Clinton Power Station

Clinton Power Station
Facility Operating License No. NPF-62
NRC Docket No. 50-461

Subject: Response to Request For Additional Information

Attachment A
Response to Request For Additional Information
Clinton Power Station, Unit 1
1 of 21

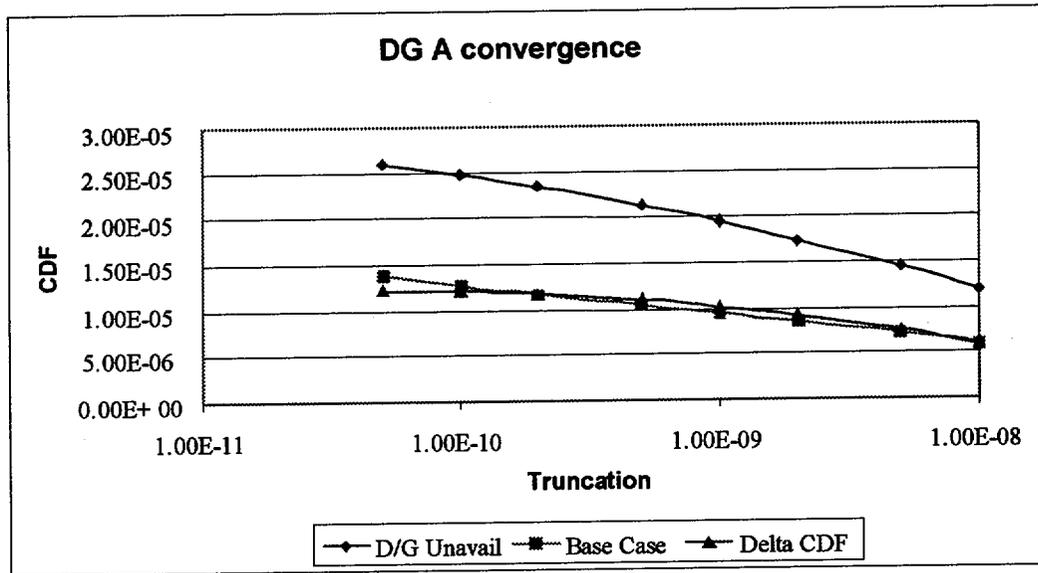
c. As described above, a peer review of the updated CPS PRA was performed in August 2000 by the BWROG in accordance with their certification guidelines. Overall, the peer review resulted in the conclusion that most of the elements of the CPS PRA were Grade 3 or suitable for supporting risk-informed applications such as changes to the TS. The review team made 5 F&Os with the significance level of "A" and 91 F&Os with the significance level of "B". The significance levels have the following definitions.

- A - Extremely important and necessary to address for ensuring the technical adequacy of the PRA, the quality of the PRA, or the quality of the PRA update process.
- B - Important and necessary to address, but may be deferred until the next PRA update.

We have prioritized these F&Os for response, and the highest priority F&Os are shown in Table 1. As explained on the last page of that table, the list includes all significance level "A" F&Os, and all significance level "B" F&Os that are related to a sub-element receiving a grade less than "3." Table 1 also summarizes the impact the F&Os would have on the EDG AOT risk study. The majority of the items identified in Table 1 would have minimal impact on the risk study because they do not impact Loss of Offsite Power (LOOP) events or systems used to mitigate LOOPs (e.g. a number deal with Anticipated Transient Without Scram (ATWS) or Interfacing System Loss of Coolant Accident (ISLOCA) events). The current core damage frequency (CDF) estimate for CPS from internal events including flooding (i.e., $\sim 1.3E-5/\text{yr}$) and from quantified external events like fire (i.e., $\sim 3E-6/\text{yr}$) place this risk analysis on the left side of Region III as defined in Figure 3 from Regulatory Guide 1.174. Changes in base CDF resulting from resolution of all certification comments in the future is expected to have only a minimal impact on this position. Those F&Os which required model revision or sensitivity studies for the EDG AOT extension are described below.
